# UNITED STATES PATENT AND TRADEMARK OFFICE

10/539,922

| <b>Office Action Summary</b> | <b>Application No.</b> | <b>Applicant(s)</b> |  |

## **DETAILED ACTION**

FIG. 2

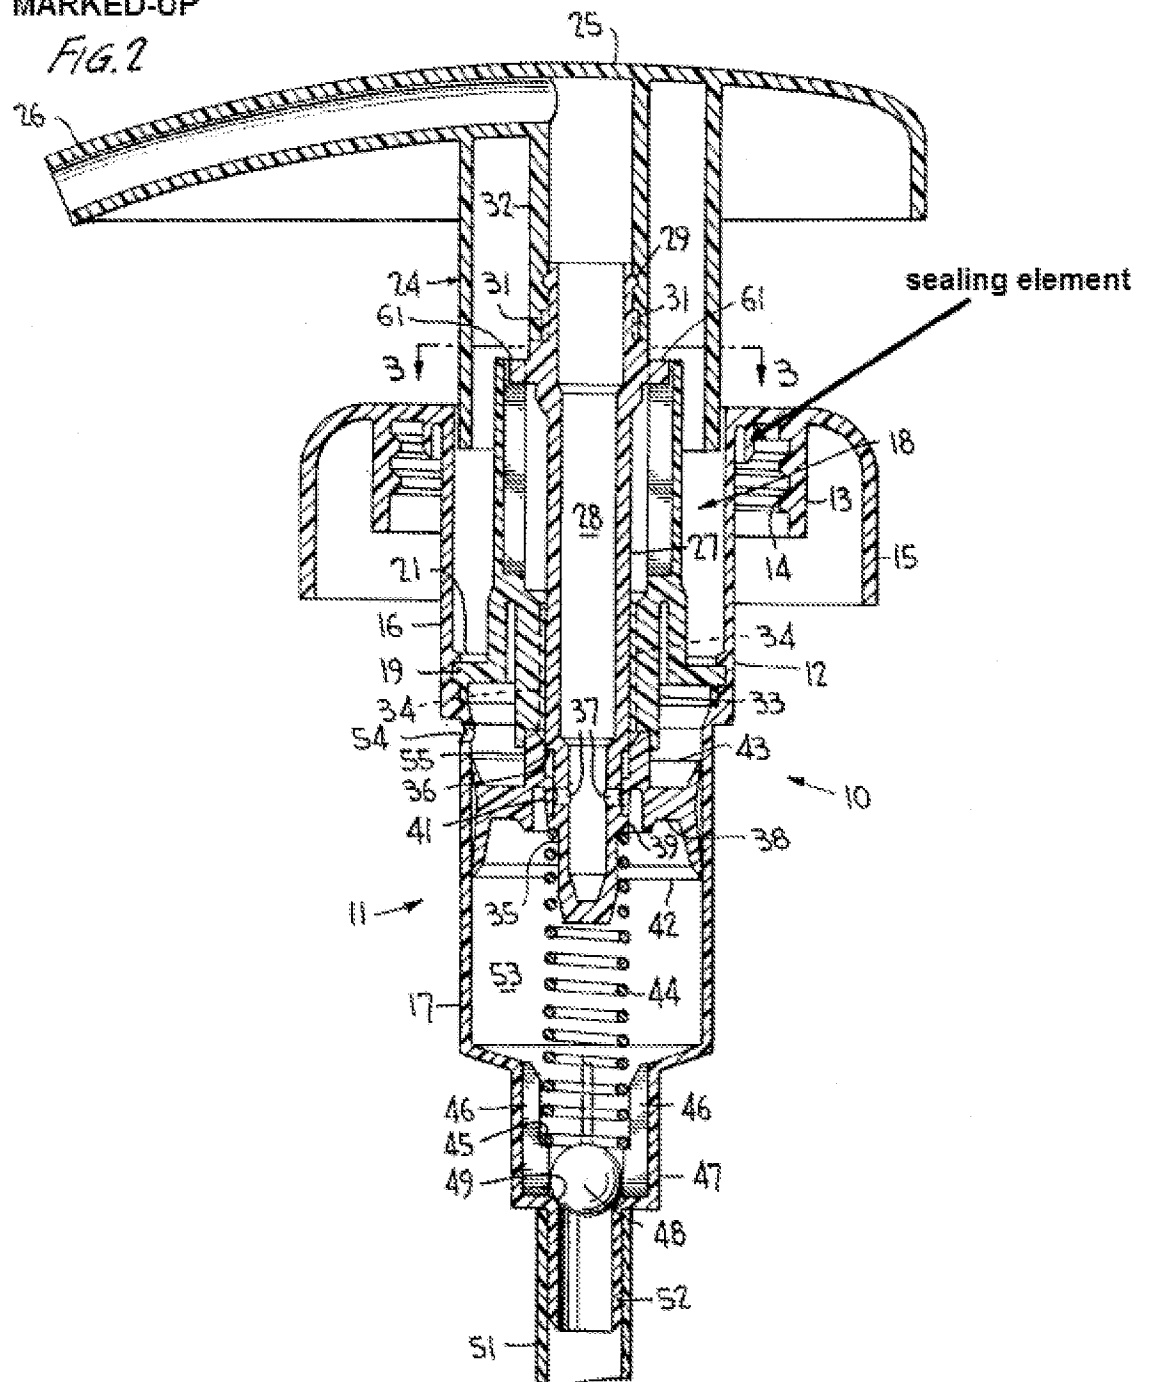
Regarding claim 1, Grothoff discloses a fluid dispenser comprising an inlet (49) and a discharge opening in a nozzle (26), wherein the inlet and the discharge opening are disposed separate from each other, a dosing and displacement chamber (53) provided between the inlet and discharge opening, wherein the inlet and discharge opening are closable by closure means (39, 41).

Regarding claim 9, a sealing element (see marked-up FIG. 2) is disposed in the screw fastening.

MARKED-UP
